Access Compliance Report

Public Rights-of-Way

Intersection ID: 4270	Main Street: N_TRYON_ST	Cross Street: SALOME_CHURCH_RD	Location: NW
ADA ID: 2B2C723F99CE	Ramp Type: Perp	Initial Pass/Fail: Fail	Overall Compliance: No
		Severity Score: 37.5

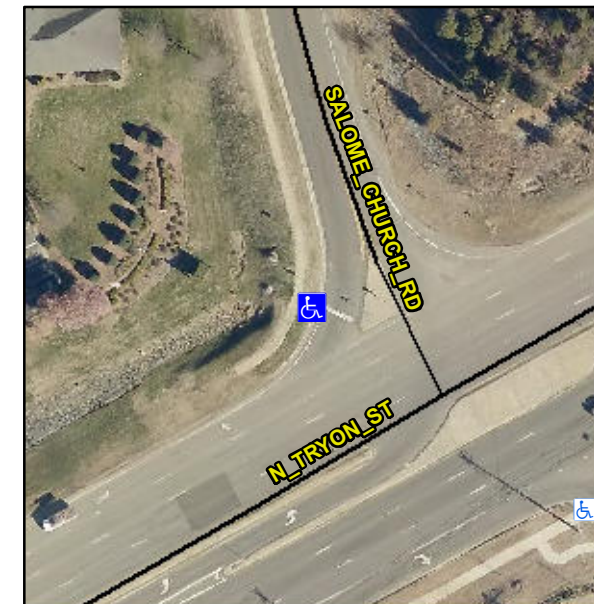
Not Found, R304.2.2, R304.5.3

Compliance	Description	Data	Compliance	Description	Data
N/A	Ramp Length (in)	97.0	No	Ramp Slope (%)	16.8
Yes	Ramp Width (in)	56.0	No	Ramp XSlope (%)	5.4
N/A	Flare Type LT	N/A	N/A	Flare Type RT	N/A
N/A	Flare Slope LT (%)	N/A	N/A	Flare Slope RT (%)	N/A
N/A	Flare Traversable LT?	N/A	N/A	Flare Traversable RT?	N/A
N/A	Landing Length (in)	N/A	N/A	DWS Provided?	N/A
N/A	Landing Width (in)	N/A	N/A	DWS Contrast?	N/A
N/A	Landing Slope (%)	N/A	N/A	DWS Length (in)	N/A
N/A	Landing X Slope (%)	N/A	N/A	DWS Full Width?	N/A
N/A	Landing Curb? (Y/N)	N/A	N/A	DWS Offset (in)	N/A
N/A	Shared Landing?	N/A			
N/A	Gutter Ponding?	N/A	N/A	Gutter Slope (%)	N/A
N/A	Gutter Lip Ht (in)	N/A	N/A	Gutter X Slope (%)	N/A
N/A	Painted X Walk1?	No	N/A	Painted X Walk2?	N/A
	X Walk 1 Direction	To SE		X Walk 2 Direction	N/A
N/A	X Walk 1 Width (in)	N/A	N/A	X Walk 2 Width (in)	N/A
	X Walk 1 Slope (%)	2.4		X Walk 2 Slope (%)	N/A
	X Walk 1 X Slope (%)	5.2		X Walk 2 X Slope (%)	N/A

Remove & Replace Entire Ramp.
